DECISION

on one-time inspection of elevator actuator joint with elevator bracket for the lack of bushes.

RRJ0000-OR-470-8879/C

2.1 INTERNAL ACTUATOR (fig. D).

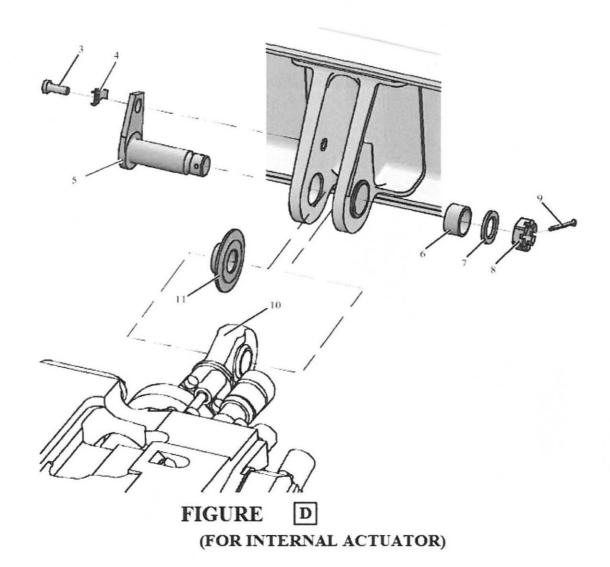
2. ELEVATOR ACTUATOR JOINT ASSEMBLING PROCEDURE.

- 1. Apply the thin layer of AЛКМ-1 compound with the brush on the bush (11) mounting surfaces;
 - 2. Install the bush (11);
- 3. Apply the thin layer of grease "Эра (ВНИИ НП-286M)" with the brush onto functional surfaces and threads of bolts 3, 5 and the bush (6);
- 4. Place elevator actuator eyelet (10) inline with actuator mounting bracket eyelets;
 - 5. Install the bolt (5) onto the bush (6);
 - 6. Install the washer (7) and fit the nut (8);
 - 7. Install the bolt (3) and a new washer (4);
 - 8. Lock the bolt (3) with the washer (4);
 - 9. Tight the nut (8) with the torque (17 ± 3) N·m [(12.5 ± 2.2) lbf·ft];

FIGURE E (FOR EXTERNAL ACTUATOR)

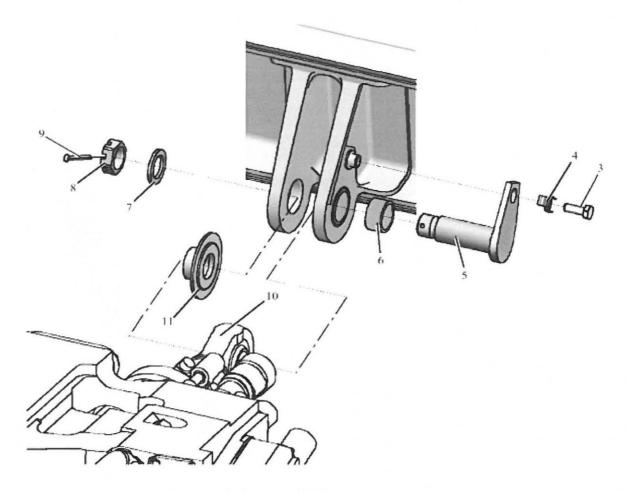
2.2 EXTERNAL ACTUATOR (fig. E).

- 1. Apply the thin layer of AЛКМ-1 compound with the brush on the bush (11) mounting surfaces;
 - 2. Install the bush (11);
- 3. Apply the thin layer of grease "Эра (ВНИИ НП-286M)" with the brush onto functional surfaces and threads of bolts 3, 5 and the bush (6);
- 4. Place elevator actuator eyelet (10) inline with actuator mounting bracket eyelets;
 - 5. Install the bush (6) on the bolt (5);
 - 6. Install the bolt (5) with installed bush (6) in to eyelets;
 - 7. Install the washer (7) and fit the nut (8);
 - 8. install the bolt (3) and a new washer (4);
 - 9. Lock the bolt (3) with the washer (4);
 - 10. Tight the nut (8) with the torque (17 ± 3) N·m [(12.5 ± 2.2) lbf·ft];
 - 11. Lock the nut (8) with the new cotter pin (9).
